Access Compliance Report Public Rights-of-Way (Curb Ramps)

Main Street: DORRANCE_DR		Cross Street: O_NEILL_DR		Location:	NE
ADA ID: RPRK211026133819	Ramp Type:Type 1 - Perpendicular	Initial Pass/Fail: Fail	Overall Compliance: No	Severity Score:	32
Codes/Mitigation Info/Possible Solution			Field Measurements/Component Compliance

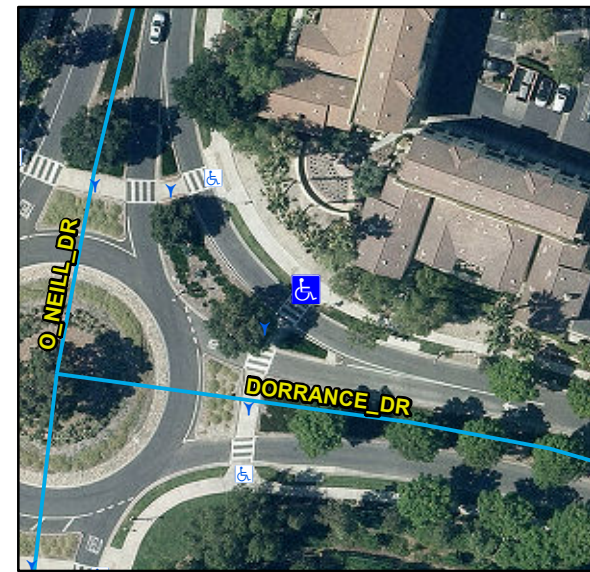
R304.2.2, R204.3, R304.5.3, STD 1115

Remove & Replace Entire Ramp.
